# METROPOLITAN GOVERNMENT OF NASHVILLE AND DAVIDSON COUNTY

## STAFF RECOMMENDATION

1413 Russell Street  
January 18, 2012

**Application:** Infill

**PLOT PLAN** Job# 0920.48 SCALE: 1" = 30'

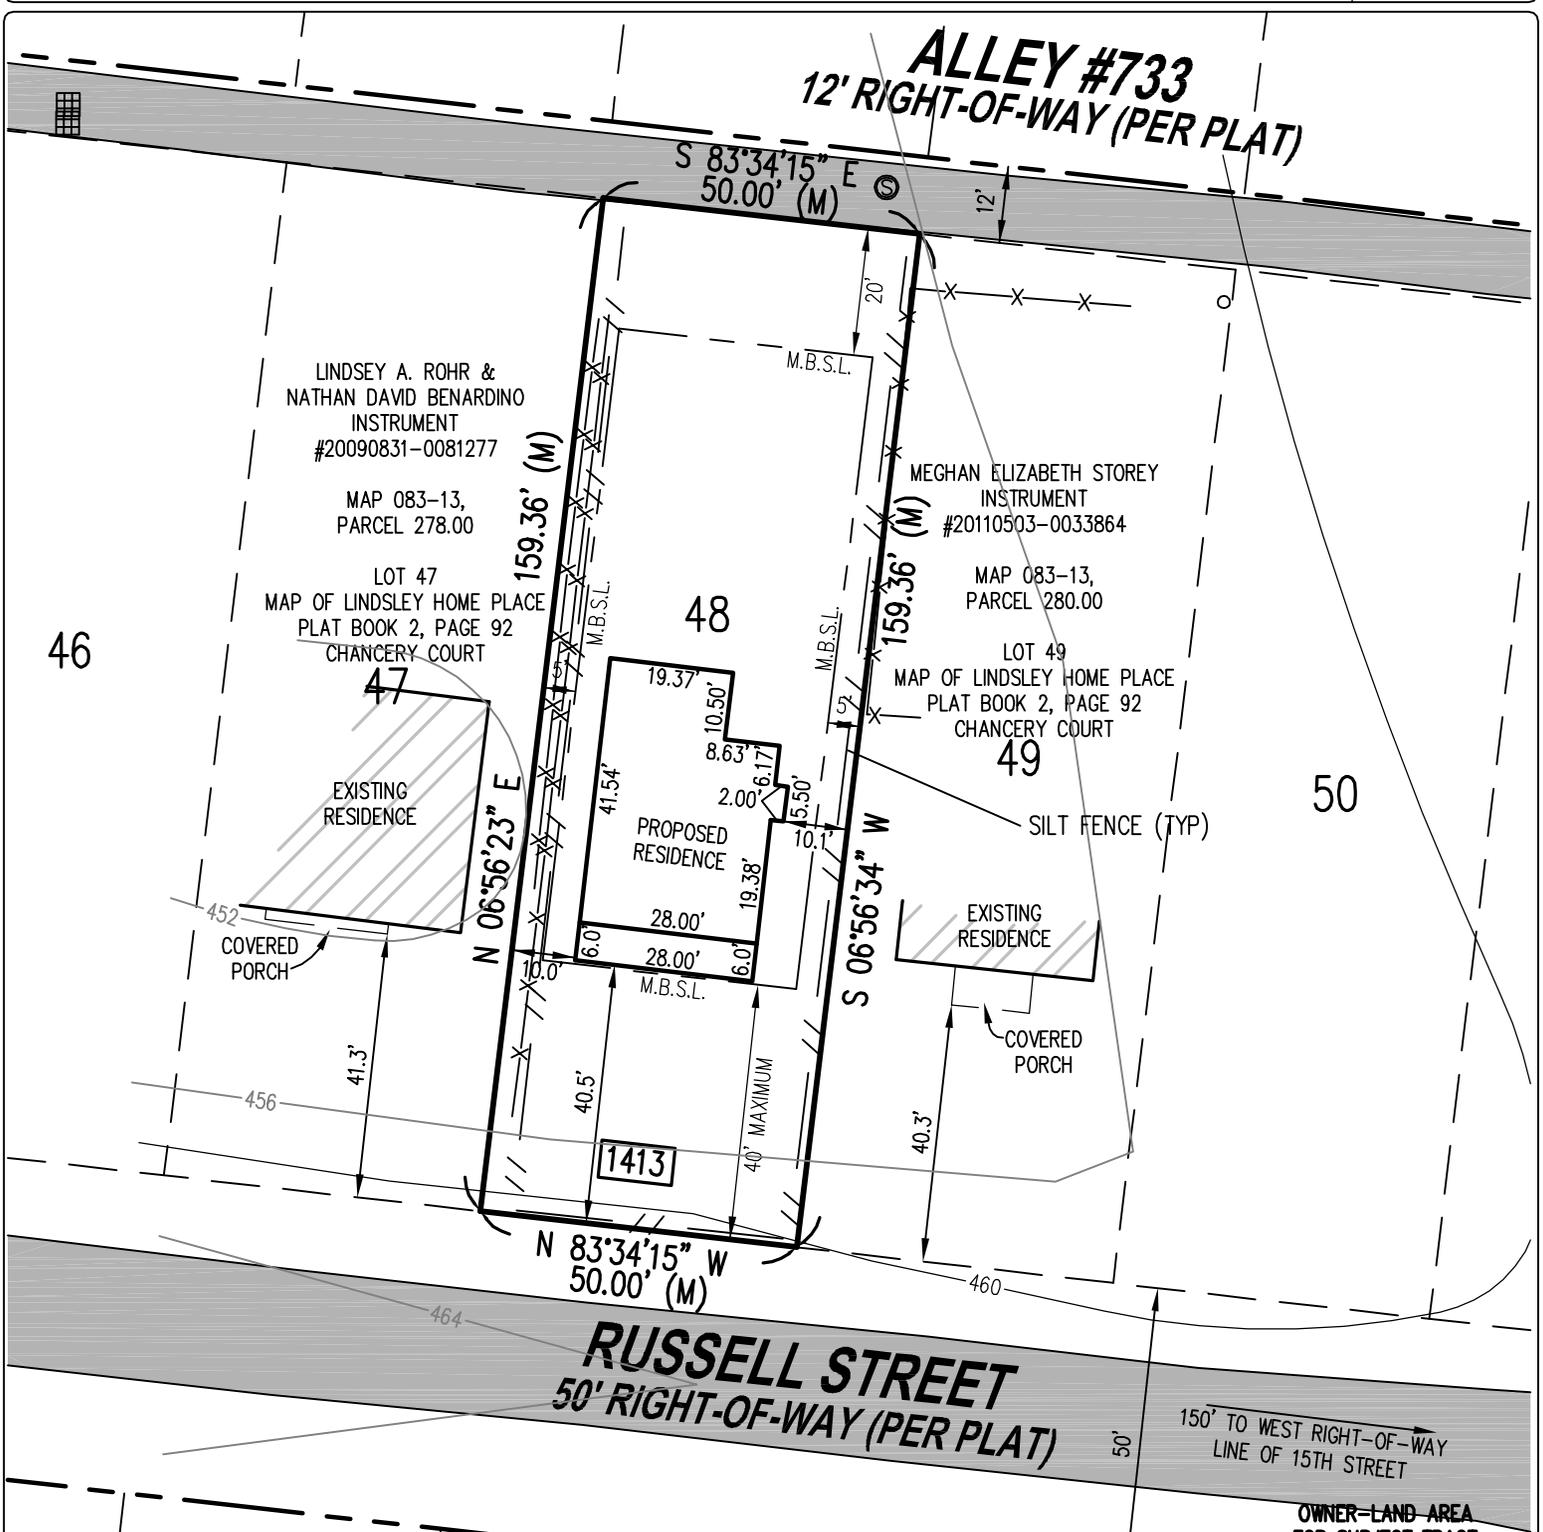
The submitted site plan and elevations do not show paving and other appurtenances. Drawings with all new site improvements, including paving, fences, utility connections and lighting should be required before a permit will be issued.

1. Drawings be corrected so that all measurements and labels match and show any appurtenances, including but not limited to paving, lighting, fences, and utility connections;
2. The porch beam shall be increased to a minimum of twelve inches (12”);
3. The water-table band should be lowered so that the top of the band aligns with the porch floor level;
4. The chimney material shall be masonry, or shortened to resemble a “box-bay;”
5. The front door and the porch design be Craftsman-style, appropriate to the general style of the house; and
6. The two windows nearest to the front on the left elevation shall be moved back from the front corner of the house. The first story window shall be lowered to align with the other first story windows.

## First Floor Plan - 1413 Russell

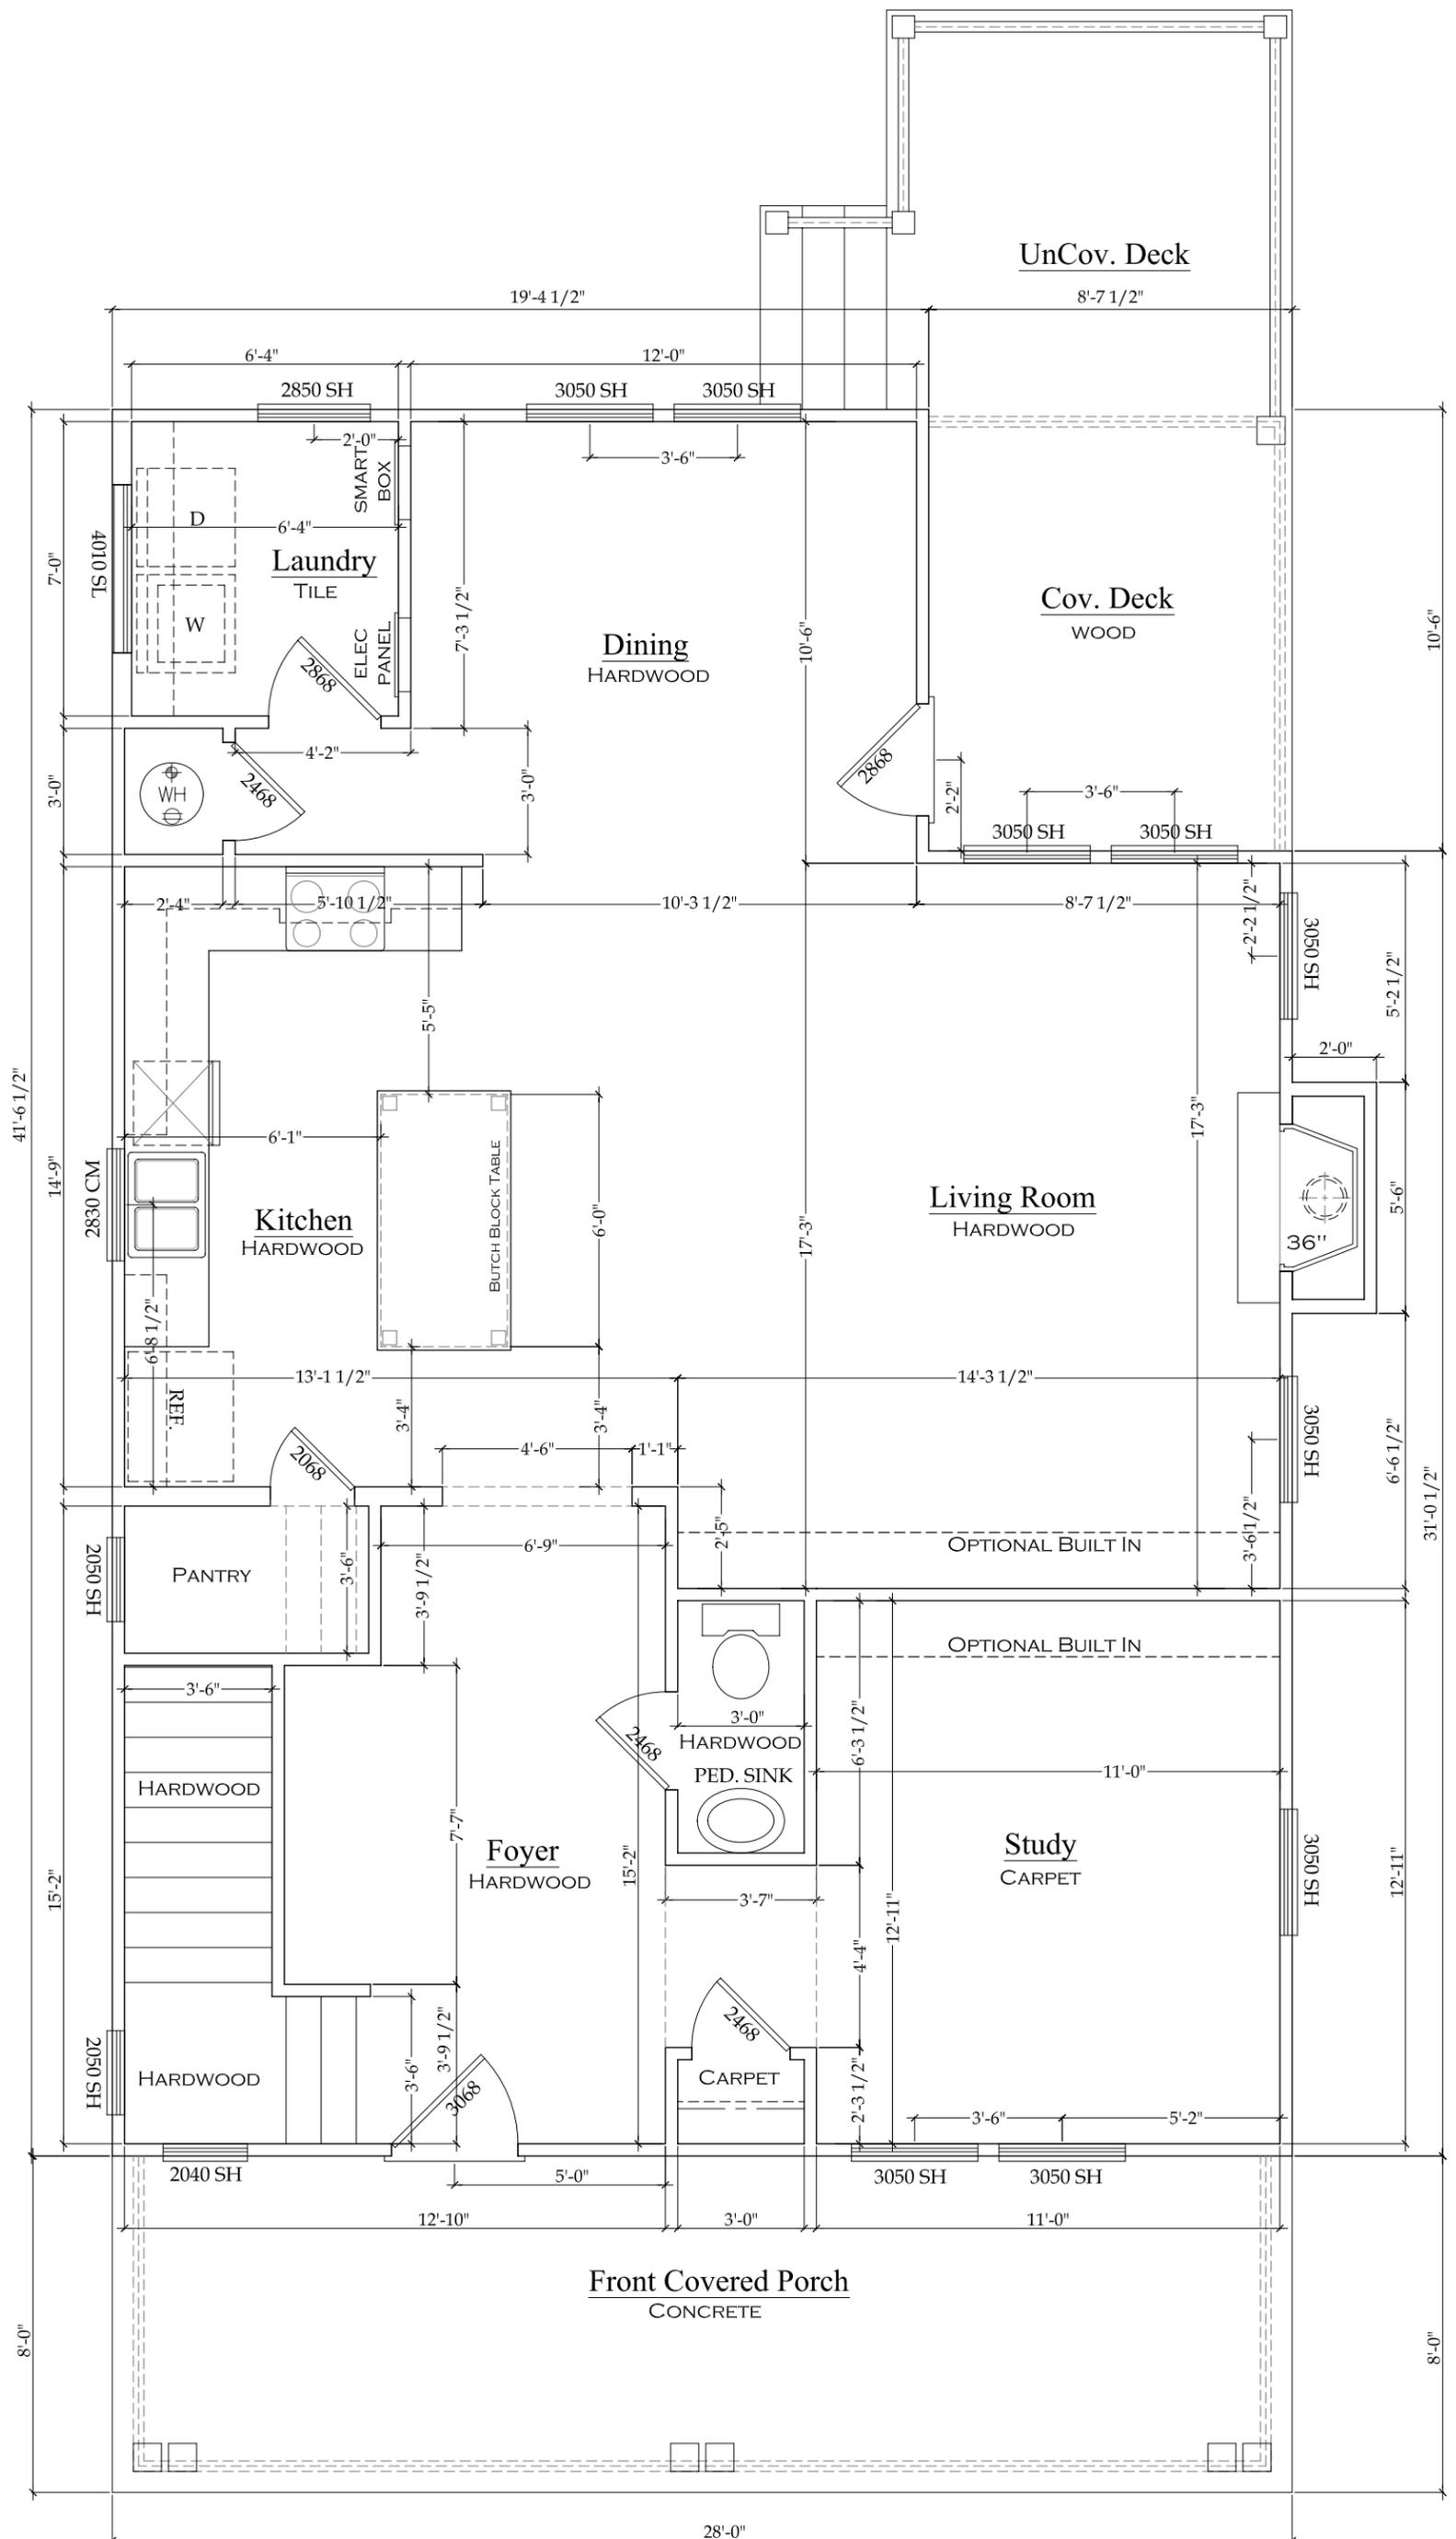
[Note – The floorplan shows the front porch as being eight feet (8') deep, but it is depicted as six feet (6') deep on the elevations. The drawing also shows a six inch (6") porch beam, but it is labeled as twelve inches (12"). All drawings should be required to be corrected with all measurements and labels matching, before a permit will be issued.)

**Left Elevation - 1413 Russell**

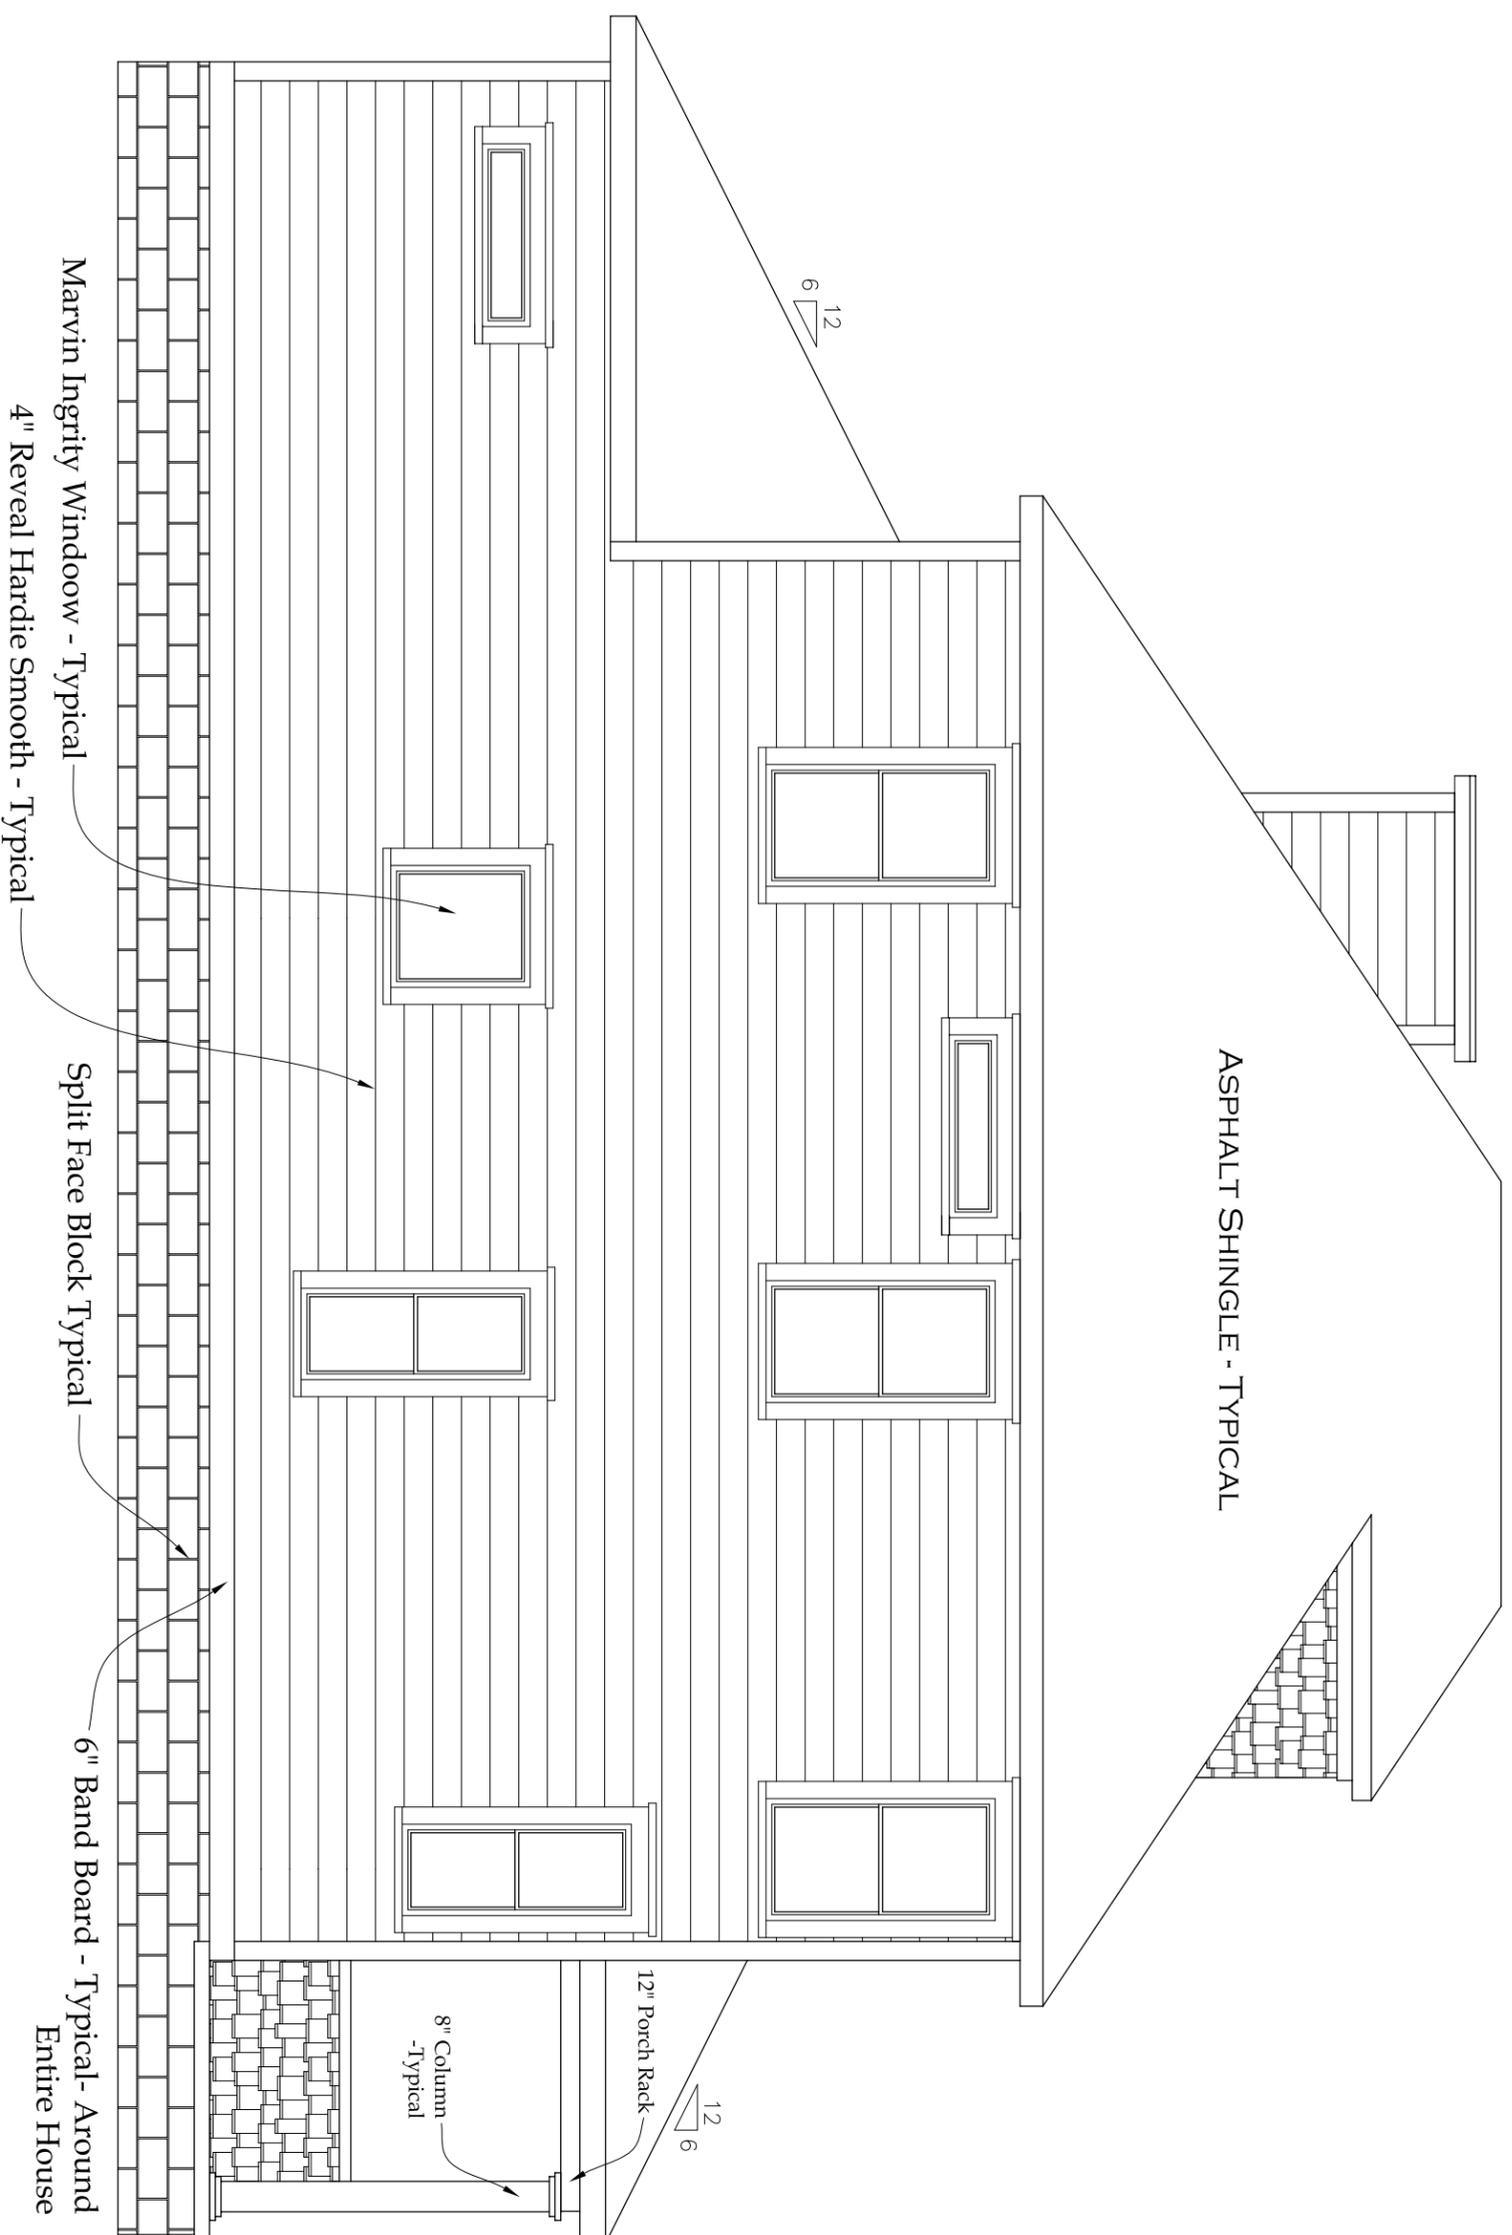
The elevations show a water-table trim band between the foundation and the first course of siding. The band is drawn so that the bottom edge is aligned with the porch floor level. Historically, this type of trim element is built so that the top of the band aligns with the floor level, with the band being the same width as the porch deck.

The visible elevations of the structure will have sufficient windows, with proportions similar to the window patterns found on surrounding historic buildings. Staff finds the placement of the two windows nearest to the front on the left elevation to be too close to

the corner, creating an incompatible appearance. Moving them both back from the front corner of the structure and bringing the first story window down closer to the height of the other windows on that level would be more appropriate, and would meet guideline II.B.7 (Proportion and Rhythm of Openings). The front and right elevations meet the guidelines as proposed with no changes recommended.
